# HISTORIC AND DESIGN REVIEW COMMISSION

May 04, 2022

**HDRC CASE NO:** 2022-239  
**ADDRESS:** 702 HAYS ST  
**LEGAL DESCRIPTION:** NCB 540 BLK 11 LOT A16  
**ZONING:** R-5, H  
**CITY COUNCIL DIST.:** 2  
**DISTRICT:** Dignowity Hill Historic District  
**APPLICANT:** Kuba Zarobkiewicz/ZAROBKIEWICZ KUBA  
**OWNER:** Kuba Zarobkiewicz/ZAROBKIEWICZ KUBA  
**TYPE OF WORK:** Construction of a rear addition  
**APPLICATION RECEIVED:** April 04, 2022  
**60-DAY REVIEW:** Not applicable due to City Council Emergency Orders  
**CASE MANAGER:** Rachel Rettaliata

1 NEW FLOOR PLAN  
SCALE: 3/8" = 1'-0"

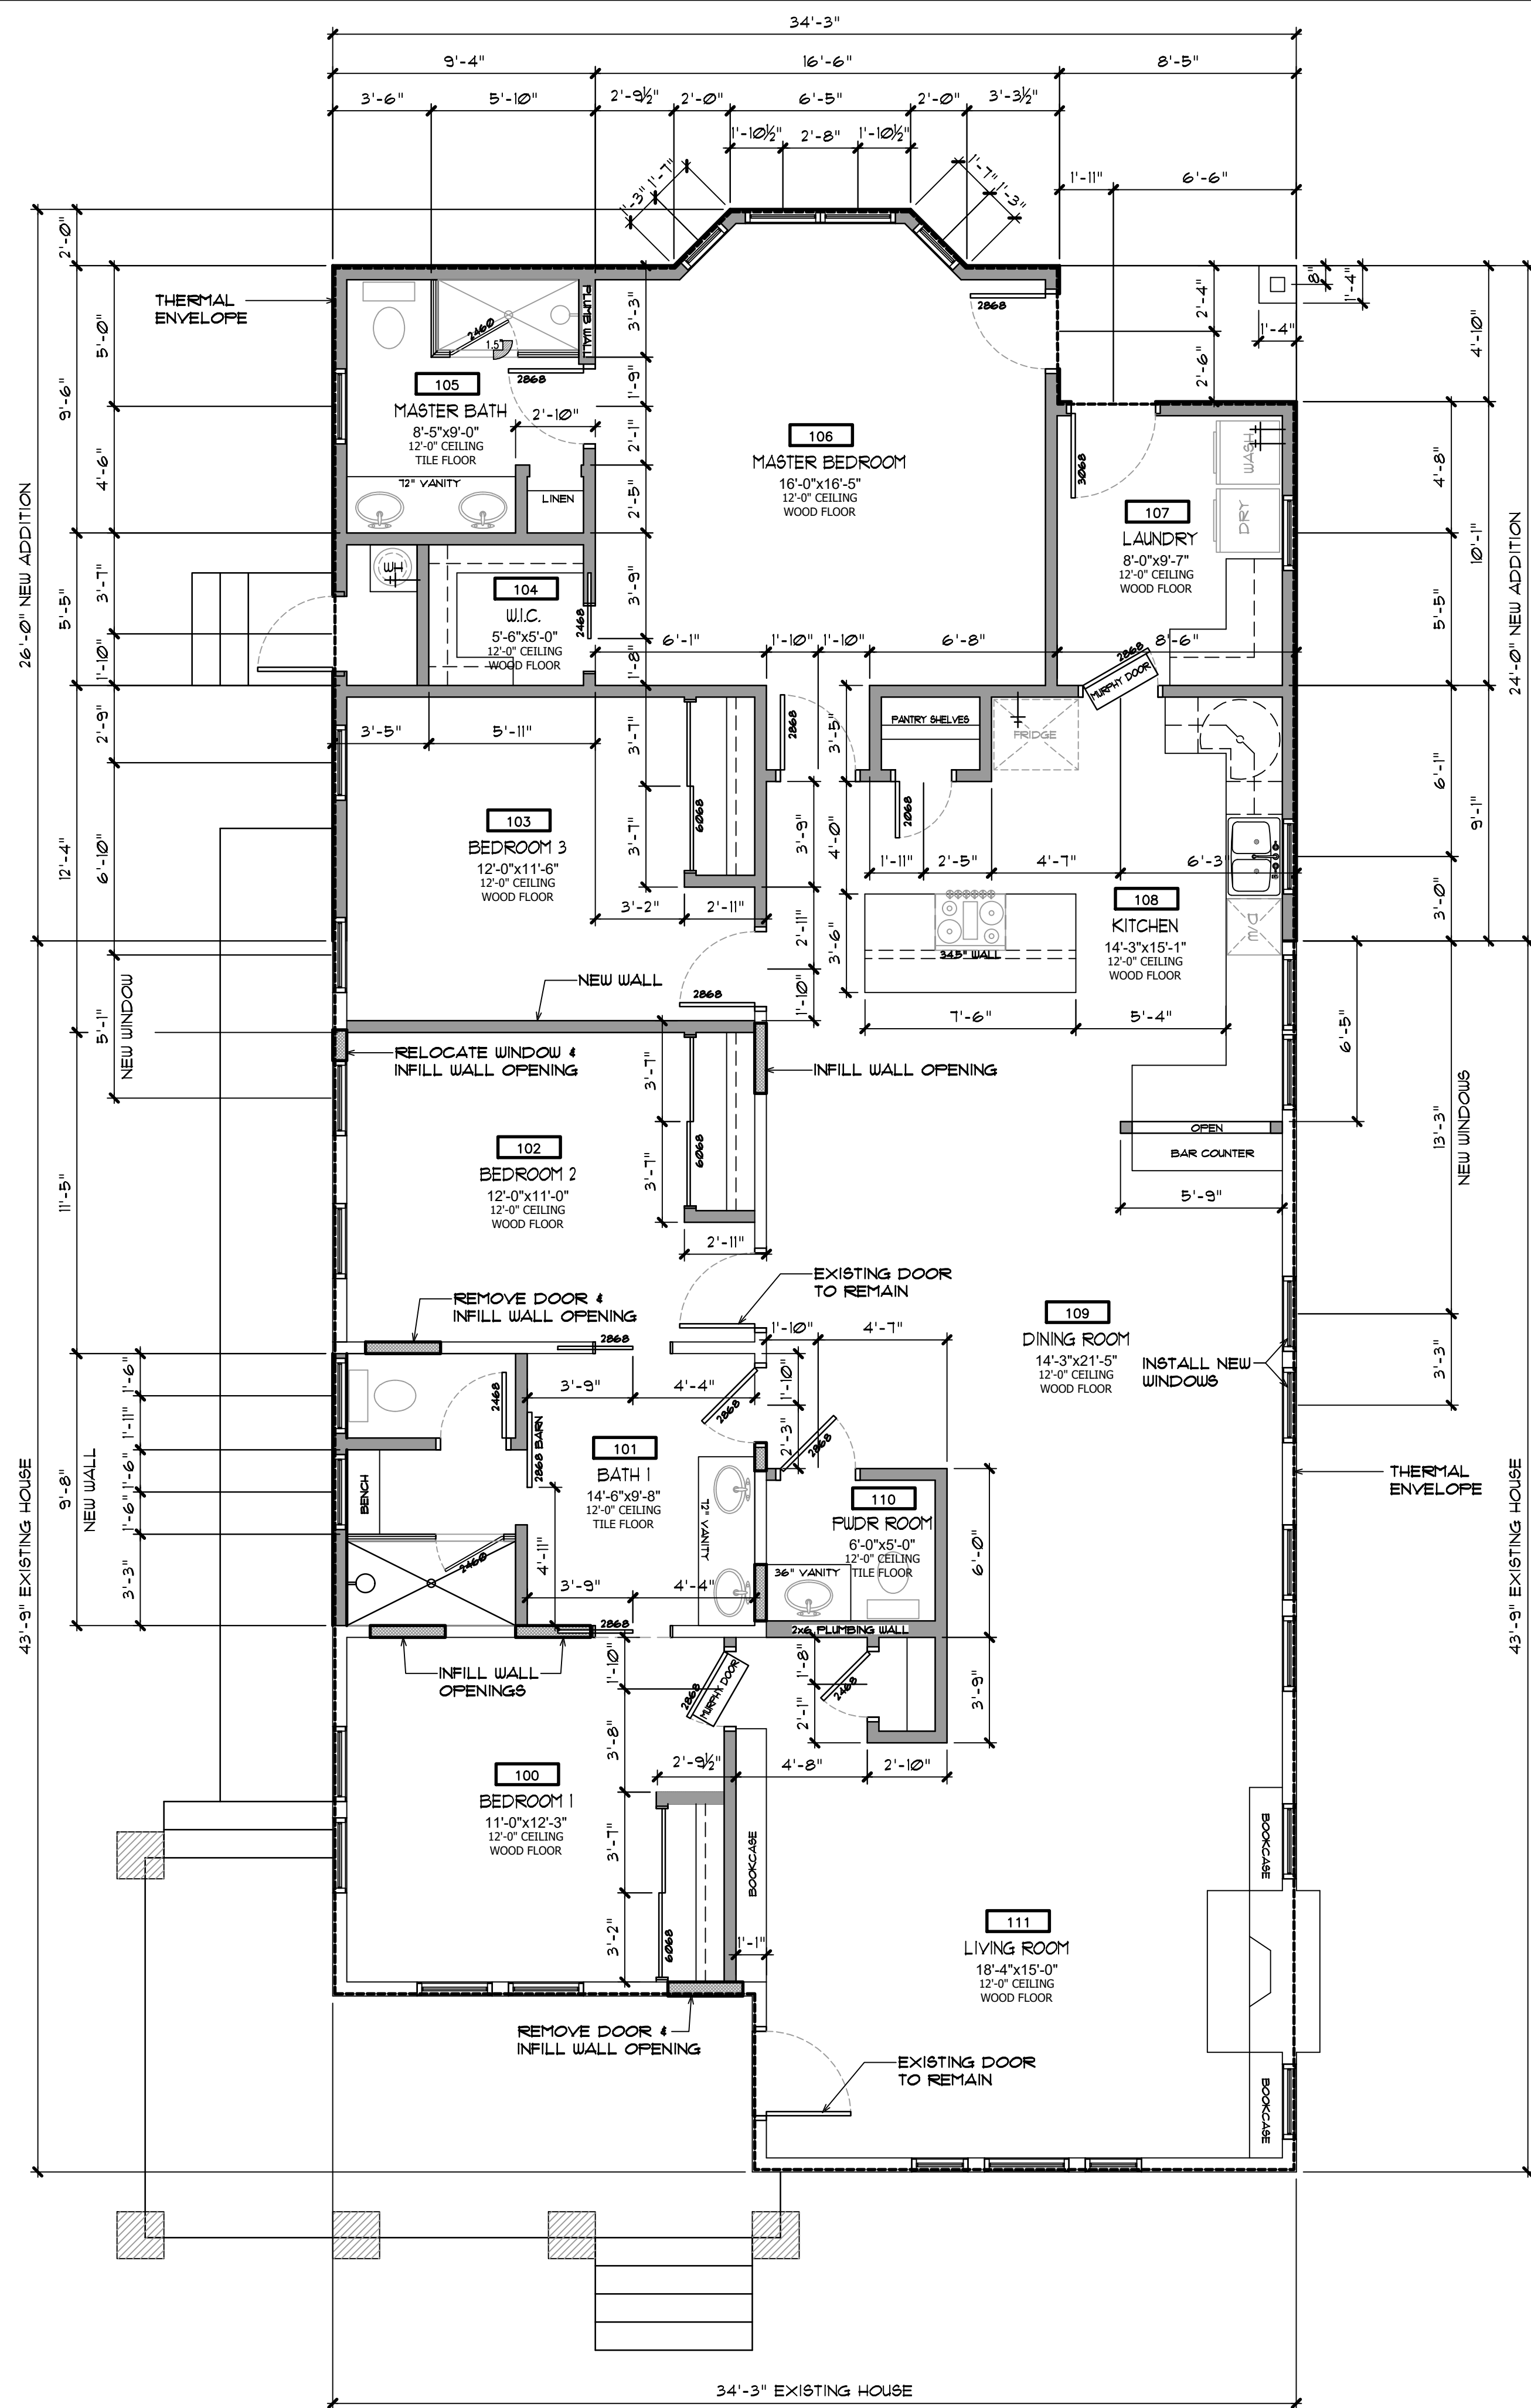
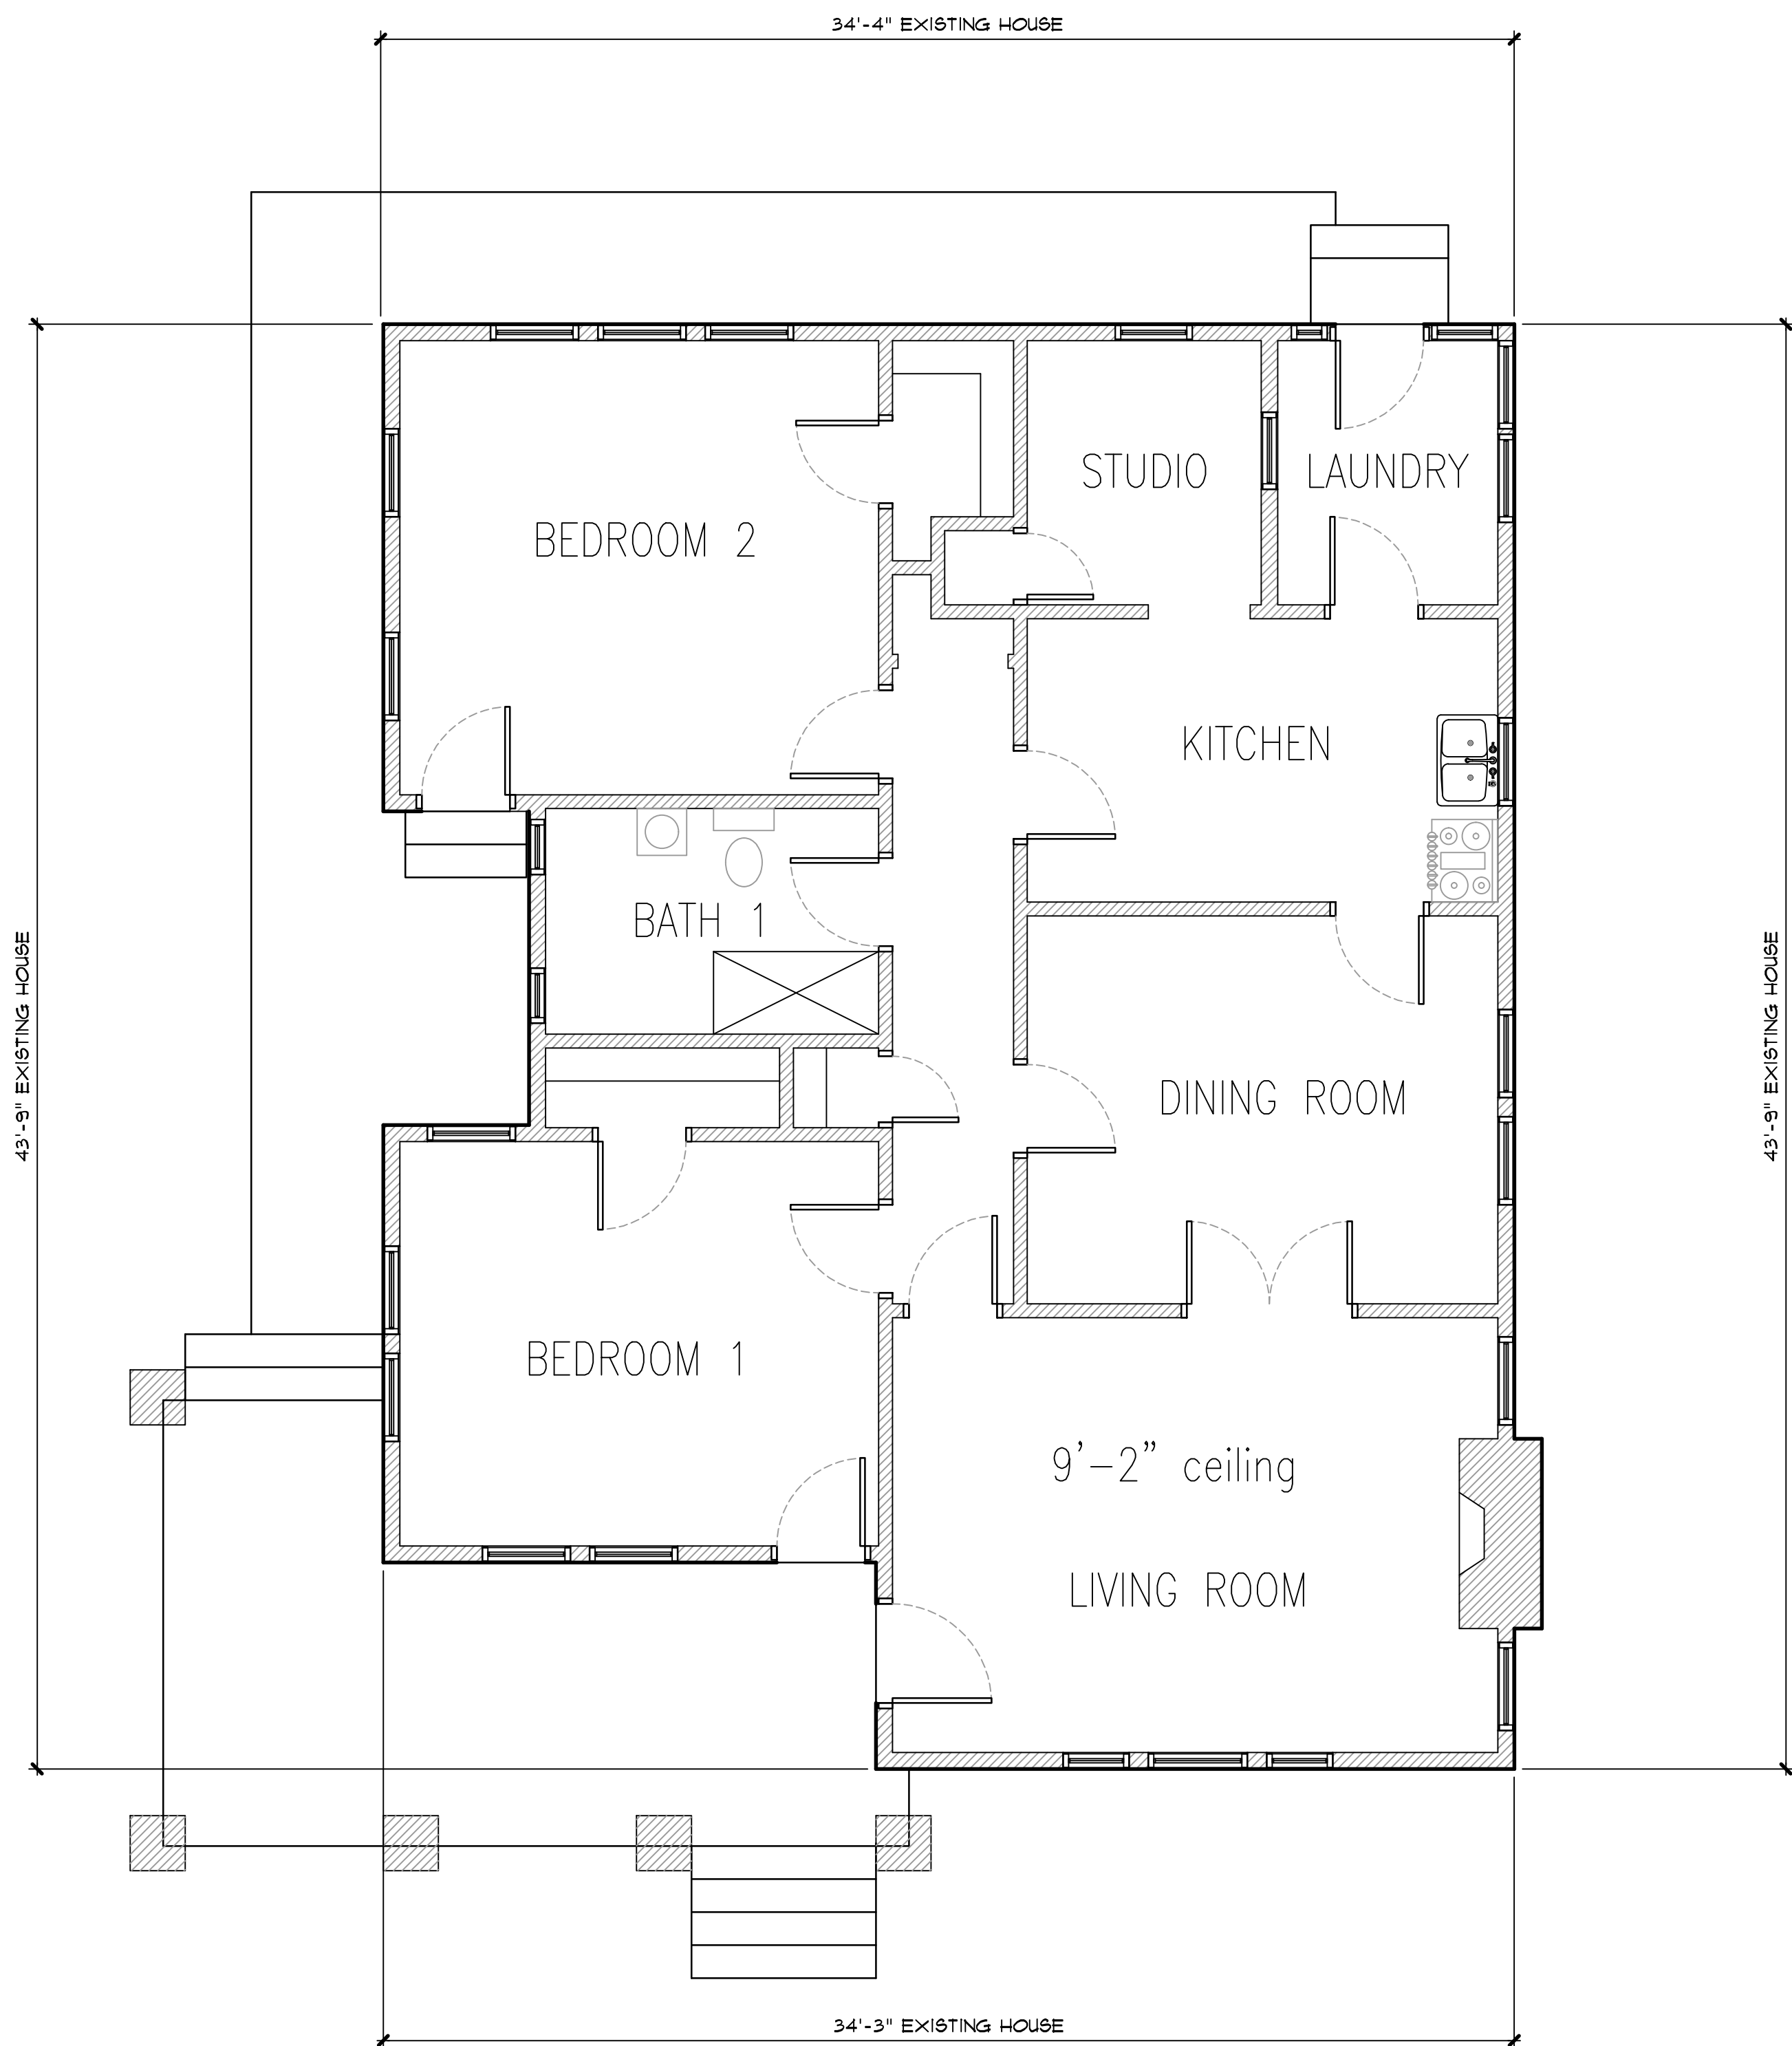
- e. REAR ADDITION – The applicant has proposed to construct a rear addition to feature 800 square feet.
- f. REAR ADDITION – The Guidelines for Additions 1.A. notes that additions should be sited to minimize view from the public right of way, should be designed to be in keeping with the existing, historic context of the block, should feature similar roof forms, and should feature a transition to differentiate the new addition from the historic structure. Additionally, the Guidelines for Additions 1.B notes that additions should be subordinate to the principal façade of the historic structure, should feature a footprint that responds to the size of the lot, should not double the existing building footprint, and should feature an overall height that is generally consistent with that of the historic structure. The existing footprint of the primary structure on site is approximately 1,240 square feet. Generally, staff finds the proposed addition to be consistent with the Guidelines.
